CITY PLAN COMISSION REPORT

Project Name
The Madison at Twin Creeks
Hearing Date March 1, 2022

Docket #	Request
13	CD-CPC-2022-00004 Development Plan (w/preliminary plat)

Plan Conditions, Corrections, & Recommendations Report

SITE PLAN

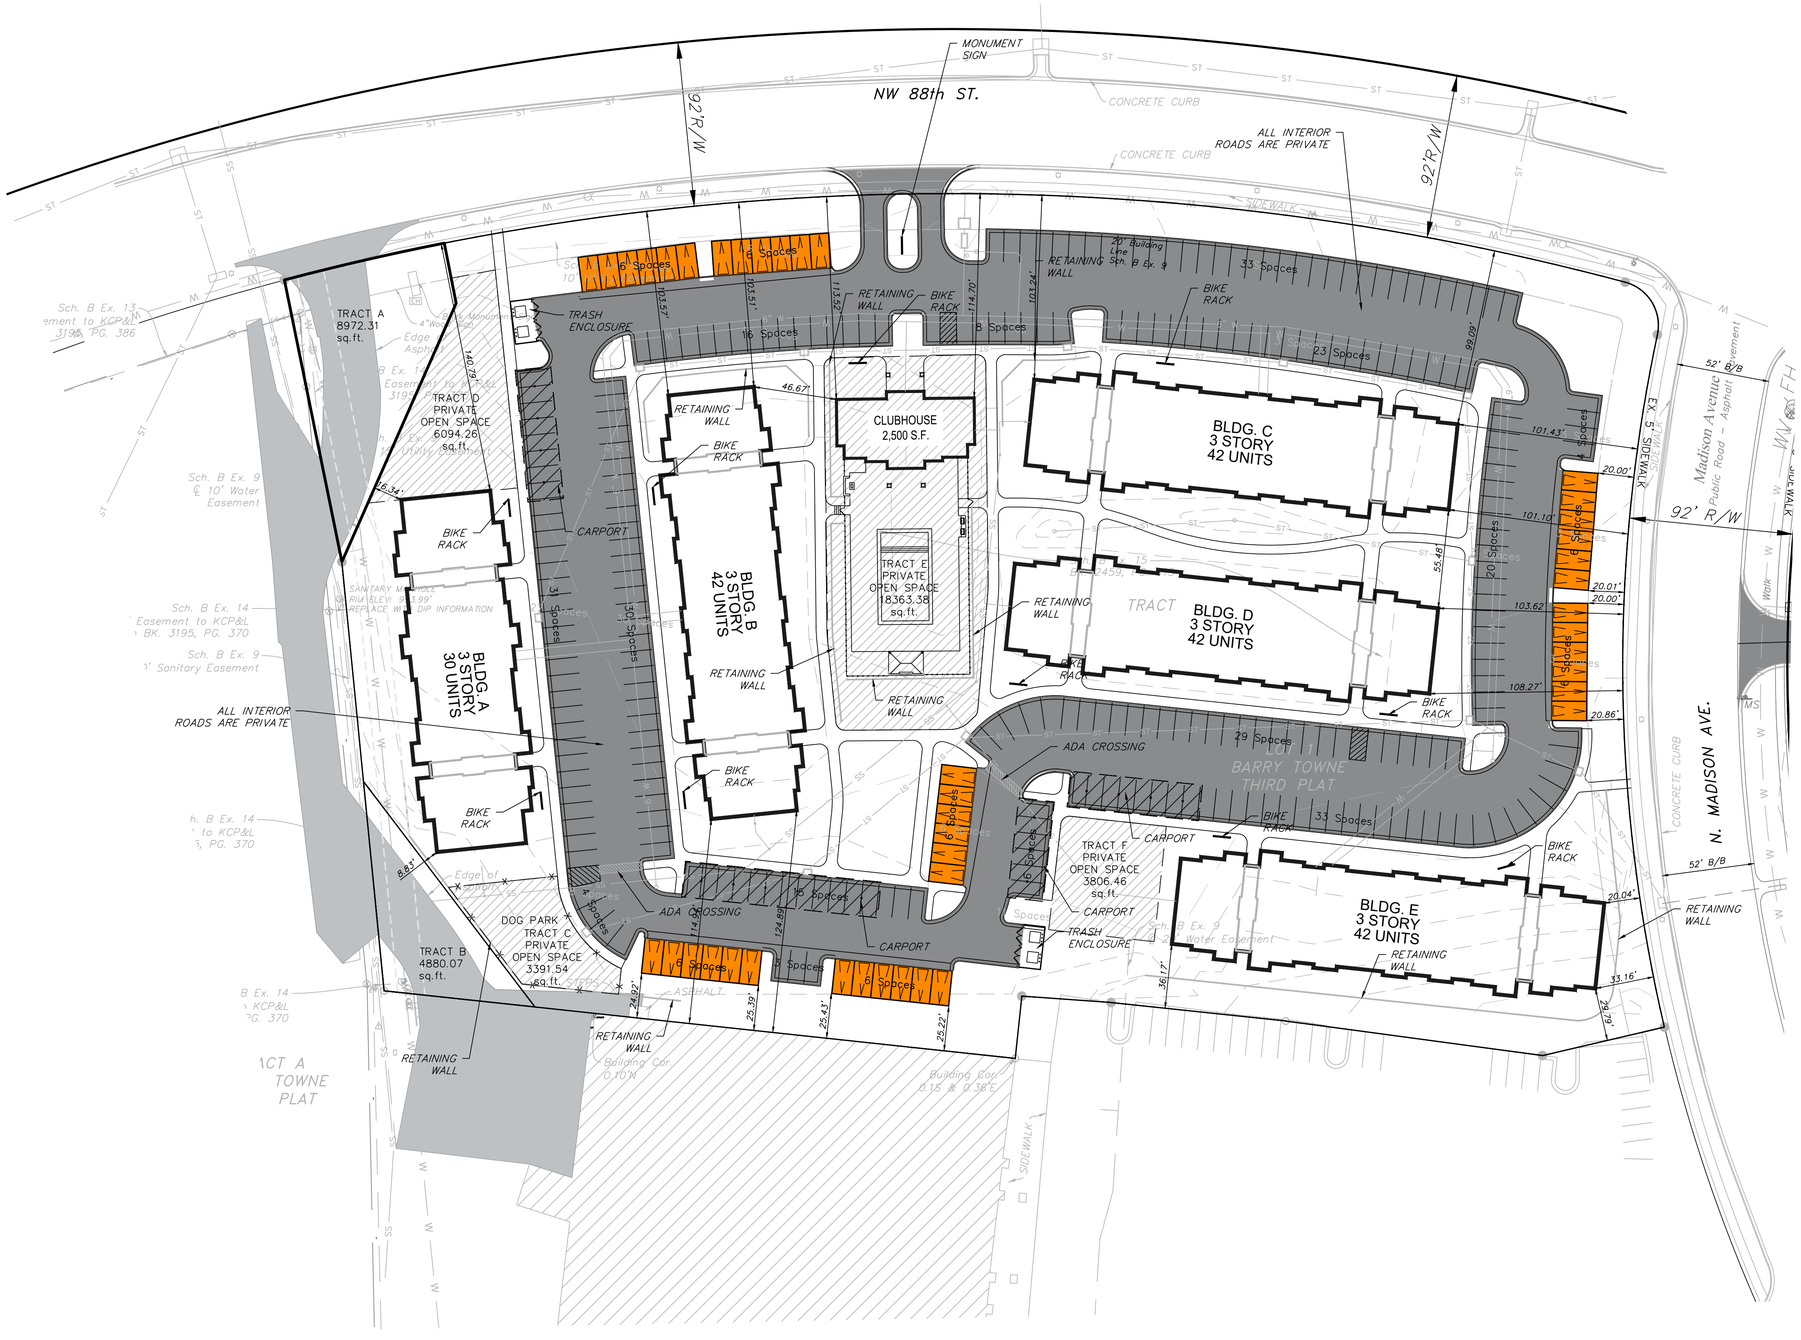
25. Label the lane widths, radii, and proposed island width for the proposed access on NW 88th St. These values will be compared to Public Works Standard Detail D-3. (1/25/2022)

LANDSCAPE PLAN

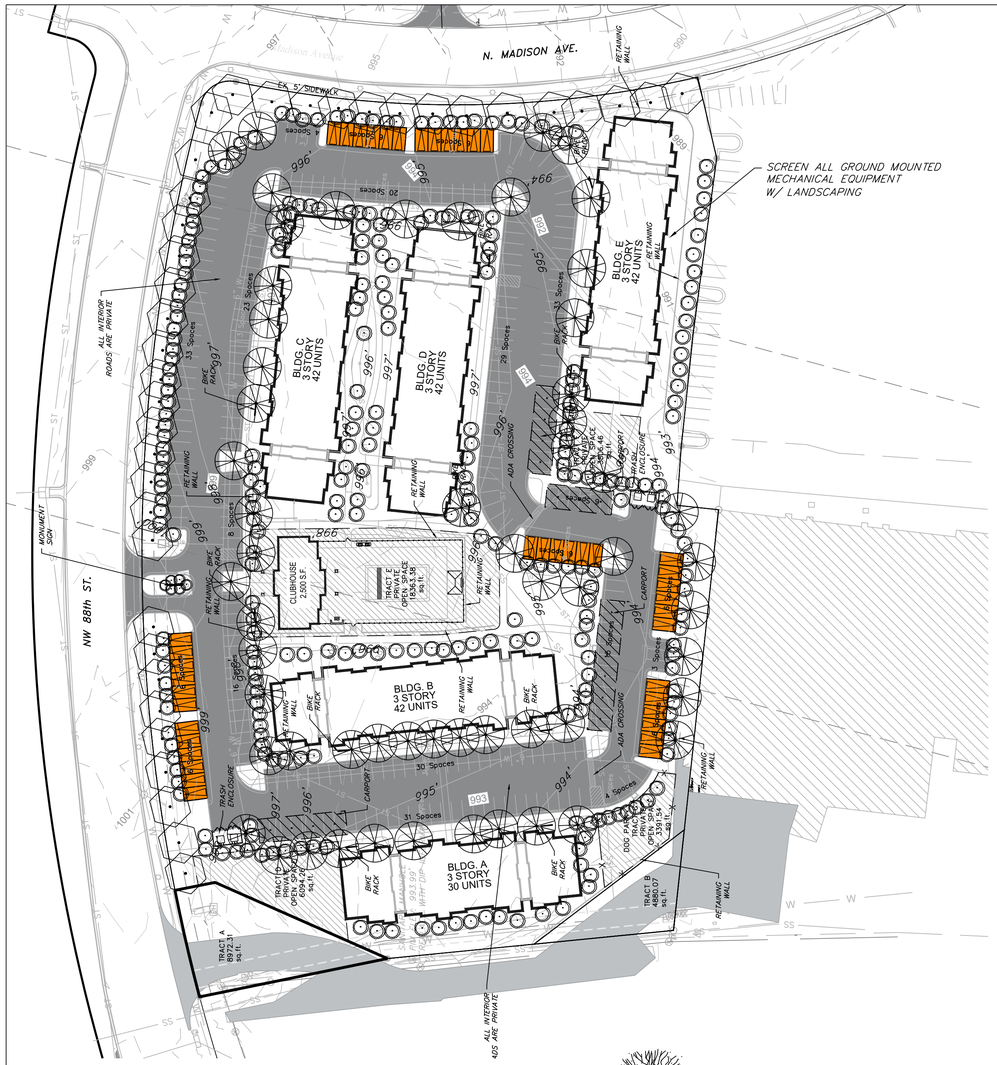
16. Provide a continuous tree and bush line from the north side of the trash enclosure to the car garage near NW 88th St. (2/17/2022)
